***ADDENDUM # 001***

**Our Lady of Fatima  
545 Baldoon Rd  
Chatham, ON**

**General Renovations & Additions for  
Mechanical Equipment**

**Project No. 619-CP1825**

DRAWING No.  
 ASK-001

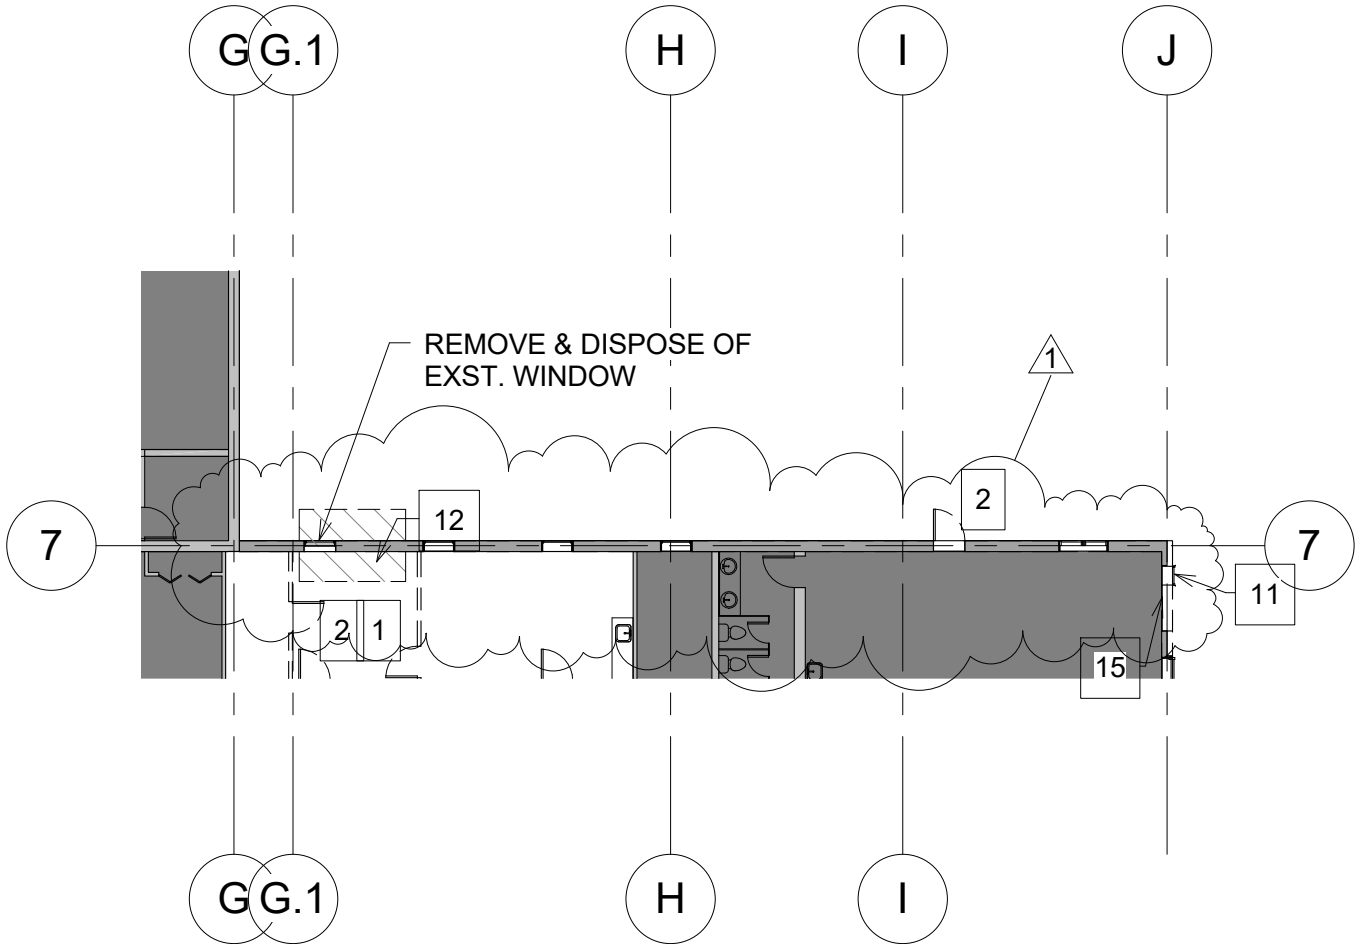
North Childcare exterior masonry wall renewal will not be done in this project phase.

PROJECT TITLE OUR LADY OF FATIMA PHASE 2 RENEWAL			DRAWING TITLE PART REFLECTED CEIL.DEMO PLAN	
SCALE 1 : 150	DRAWN BY SH	CHECKED BY RW	Reference Page No. AD200	
DATE 4/24/2018	PROJECT No. 1724		DRAWING No. ASK-002

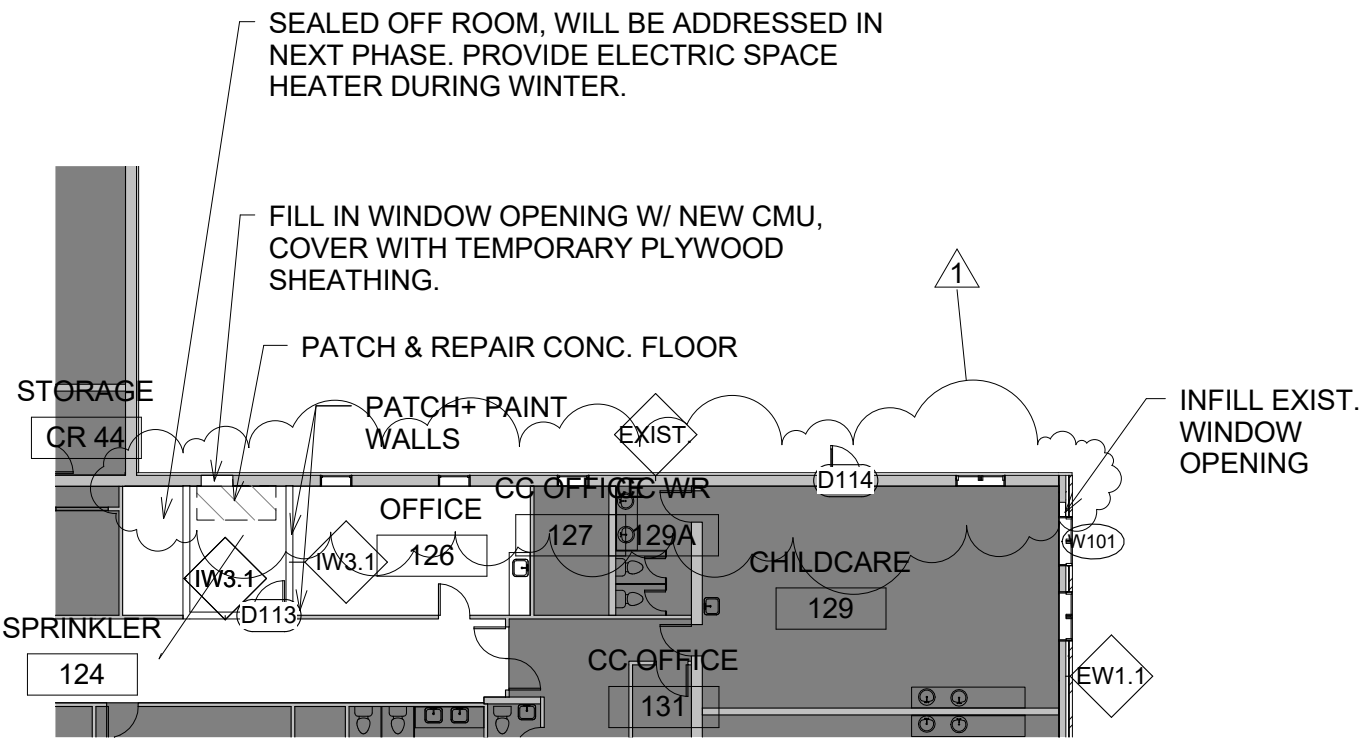
Childcare entrance canopy to have siding, lighting and soffit removed with requirements to complete new siding, soffit and lighting.  
Ceiling in classroom 110 to remain. No work done in this classroom.

PROJECT TITLE OUR LADY OF FATIMA PHASE 2 RENEWAL			DRAWING TITLE PART FLOOR PLAN	
SCALE 1 : 200	DRAWN BY SH	CHECKED BY RW	Reference Page No.	A100
DATE 4/24/2018	PROJECT No. 1724	DRAWING No. ASK-003

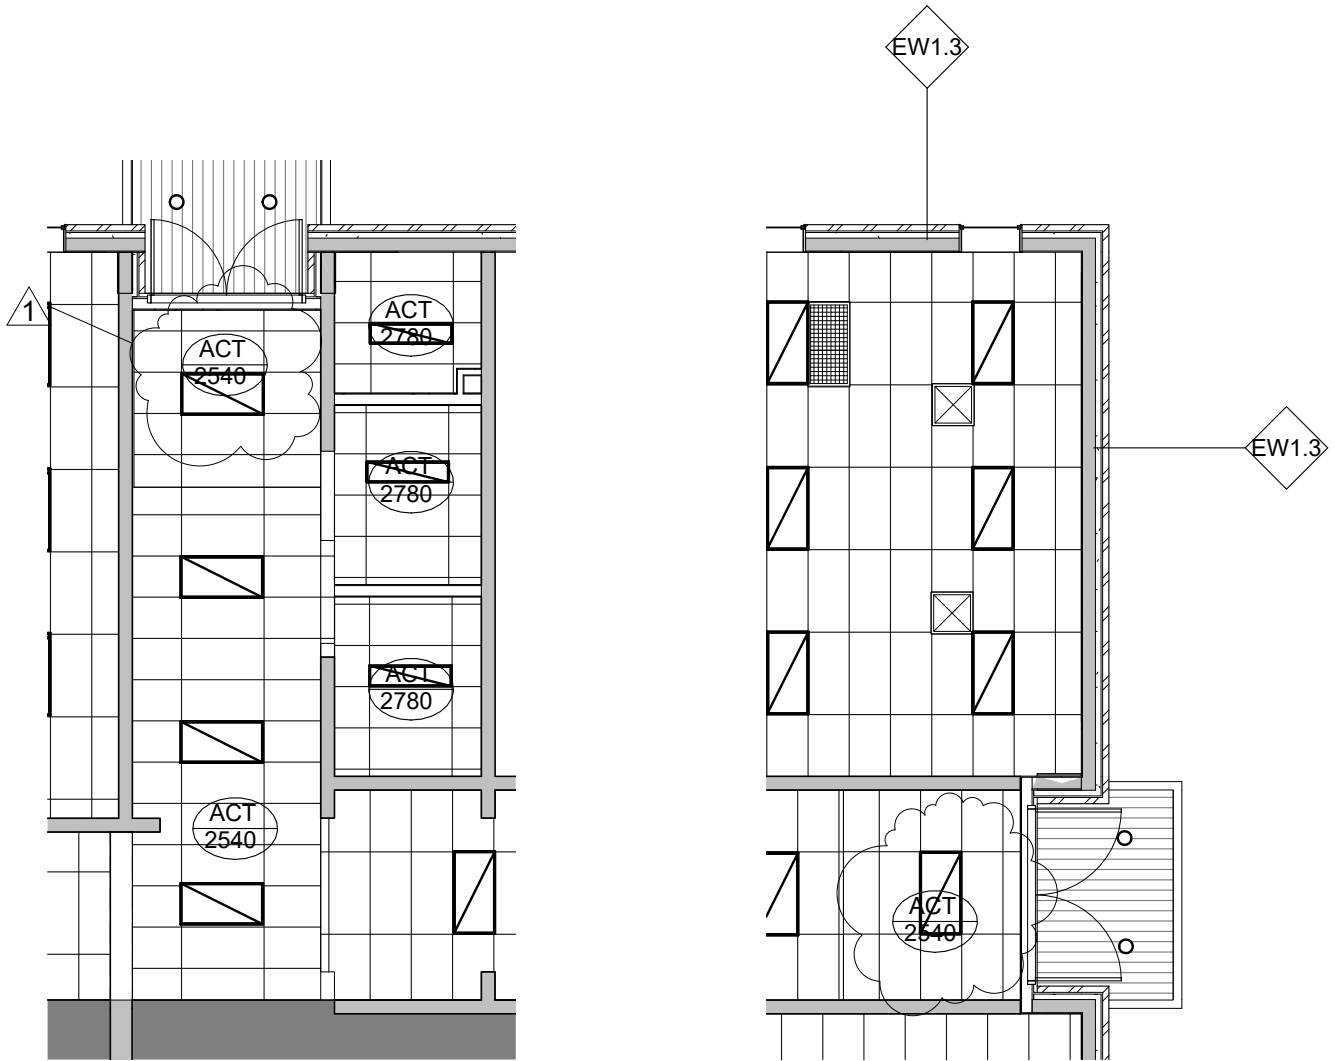
North Childcare existing wall to remain as-is except where sprinkler room work is to be done. Hose connection on north wall to be removed and reinstalled in existing location with new masonry work.

PROJECT TITLE OUR LADY OF FATIMA PHASE 2 RENEWAL		DRAWING TITLE PART REF. CEIL. PLAN	
SCALE 1 : 100	DRAWN BY SH	CHECKED BY RW	Reference Page No. A200
DATE 4/24/2018	PROJECT No. 1724	DRAWING No. ASK-004

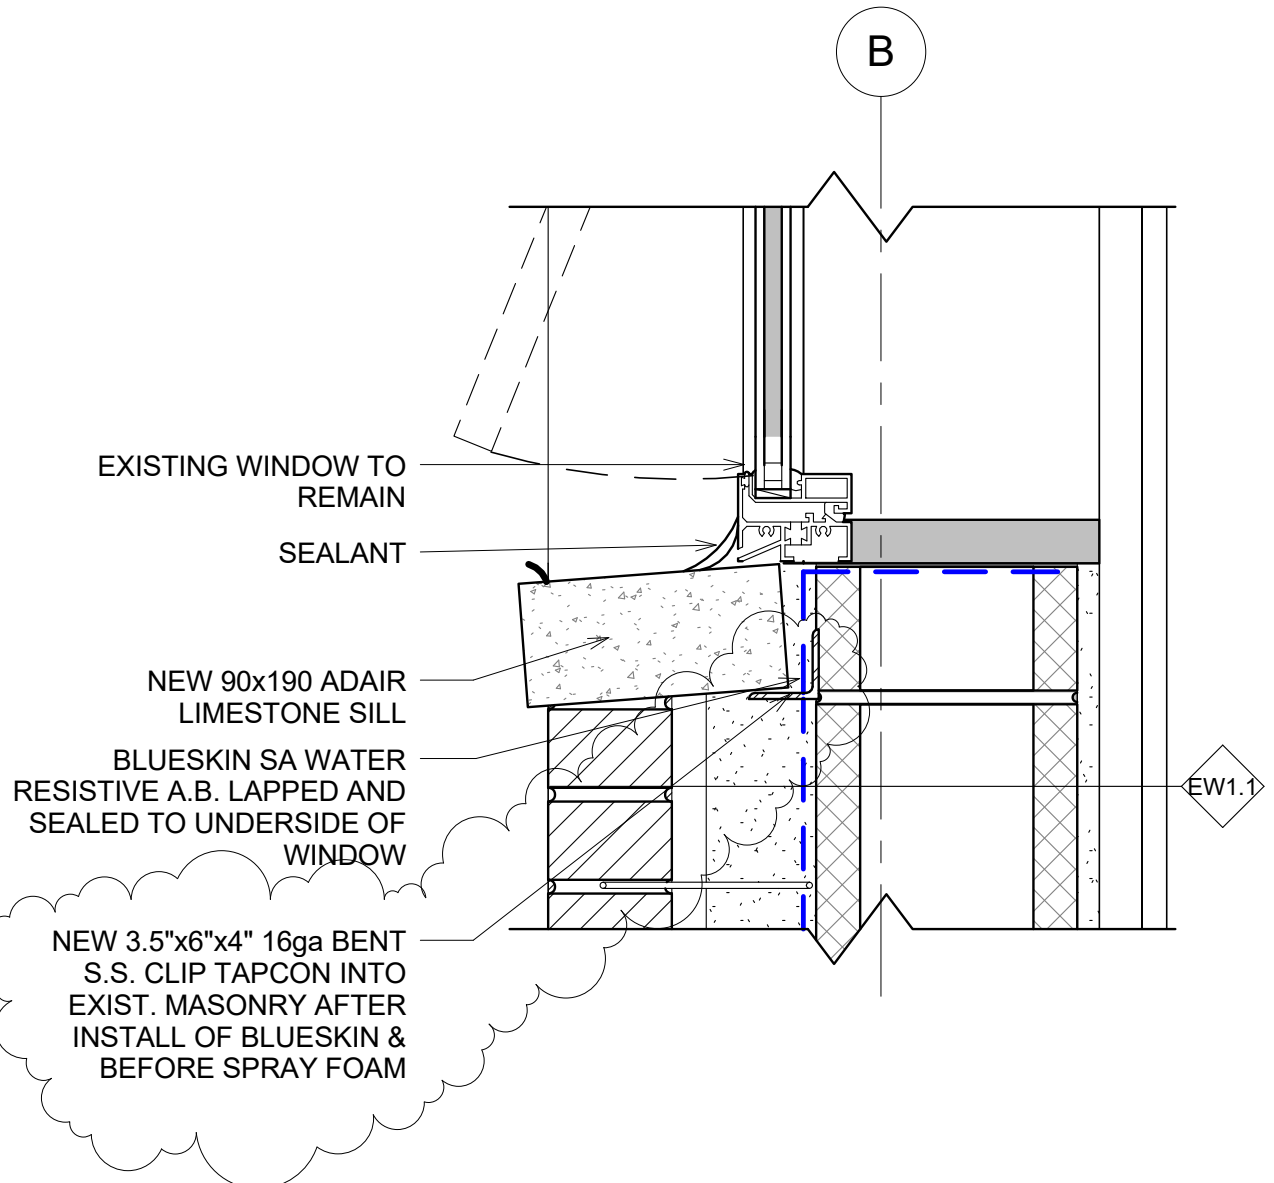
ACT ceiling height corrected to be 2540 a.f.f. @ 2 North East vestibule locations.

PROJECT TITLE <b>OUR LADY OF FATIMA PHASE 2 RENEWAL</b>			DRAWING TITLE <b>ALT. PRICE SILL DETAIL</b>	
SCALE <b>1:5</b>	DRAWN BY <b>SH</b>	CHECKED BY <b>RW</b>	Reference Page No.	<b>A625</b>
DATE <b>4/24/2018</b>	PROJECT No.	<b>1724</b>	DRAWING No.	<b>ASK-005</b>

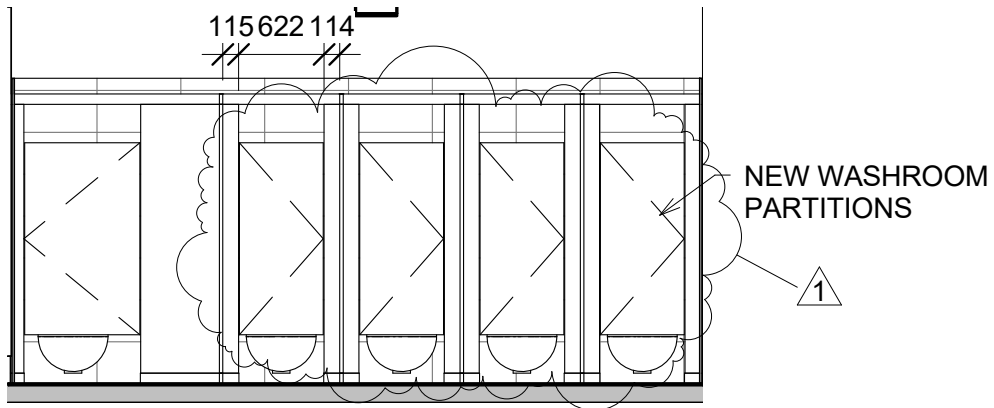
Revised to show sill clip.

DRAWING No.  
 ASK-006

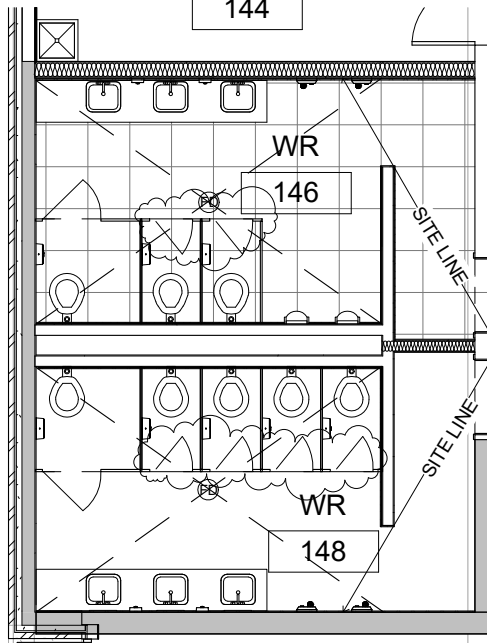
Washroom partition doors to swing inward. Pilasters incorporated into stalls, stall door is 610mm opening width.
